ENVIRONMENTAL PROTECTION AGENCY

Organobromine Production Wastes; Identification and Listing of Hazardous Waste; Land Disposal Restrictions; Listing of CERCLA Hazardous Substances, Reportable Quantities

ACTION: Final rule.

Figure 2. SAR pairs discussed by commenter

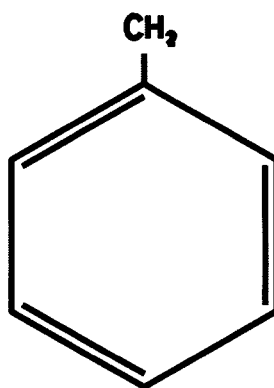
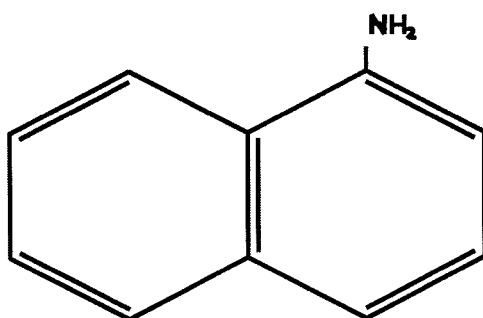
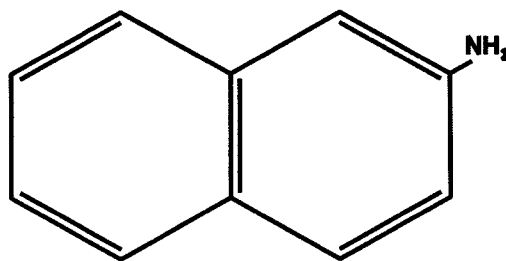
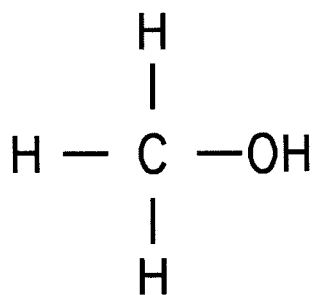
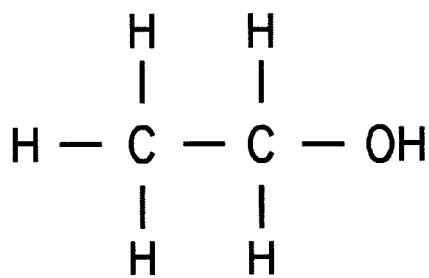
Some commenters provided examples of chemical pairs where SAR analysis would be inappropriate, such as benzene/toluene and methanol/ethanol (see Figure 2 and the accompanying text for a further discussion of these chemicals). EPA agrees that for these pairs, a SAR analysis should not be used for regulatory purposes. However, the data support a conclusion that the structural and chemical similarities

analysis and agrees that the choice of surrogate needs to carefully take into account the degree of similarity between the chemical of interest (the "candidate") and the surrogate (from which predictions are made). The structural and chemical similarities between 2,4,6-TCP and 2,4,6-TBP are greater than those in the pairs cited by the commenter. Both 2,4,6-TBP and 2,4,6-TCP consist of a phenol molecule with halogen substitutions at the 2-, 4-, and 6-positions, and differ only in the identity of the halogen. As shown in Figure 2, the differences in the pairs listed by the commenter are much

larger. The pairs cited by the commenter differ in having/not having a substituent group (benzene/toluene), or are positional isomers (1-/2-naphthylamine), homologues (methanol/ethanol, n-hexane/n-heptane), or structural isomers (MnBK/MIBK). These differences in the cited pairs have greater potential to change the chemical properties of the molecule. For example, the addition of the methyl group in the benzene/toluene pair changes the way that the molecule is converted to other molecules and removed from the body. Toluene is converted (metabolized) to compounds

between 2,4,6-TBP and 2,4,6-TCP are much stronger than those in the pairs in Figure 2, and thus the uncertainty for the current rulemaking is much less than the uncertainty/error would be for a SAR analysis for any of the chemical pairs in the counter example. EPA has determined that these data support the regulation of 2,4,6-TBP under RCRA, because they reasonably support a conclusion that 2,4,6-TBP has a level of carcinogenicity comparable to that of 2,4,6-TCP, a known carcinogen.

Thus, the structural similarities between 2,4,6-TCP and 2,4,6-TBP are greater than those between pairs of chemicals cited by a commenter in a counter-example. As described in the Listing Background Document and the Response to Public Comment Document, the physical properties of the compounds are also similar, with similar octanol/water partition coefficients and solubility in the same solvents. The available genetic toxicity data show consistent results for 2,4,6-TCP and 2,4,6-TBP, although data for the latter compound are quite limited. Finally, examples in the literature support the idea that if a chlorinated compound is a carcinogen, the compound formed by substitution of a chlorine with bromine still will be a carcinogen. Based on this line of reasoning, the Agency believes that a SAR is appropriate in this case, and the very strong chemical similarities between 2,4,6-TCP and 2,4,6-TBP justify the use of the cancer slope factor for 2,4,6-TCP as a default value for 2,4,6-TBP.
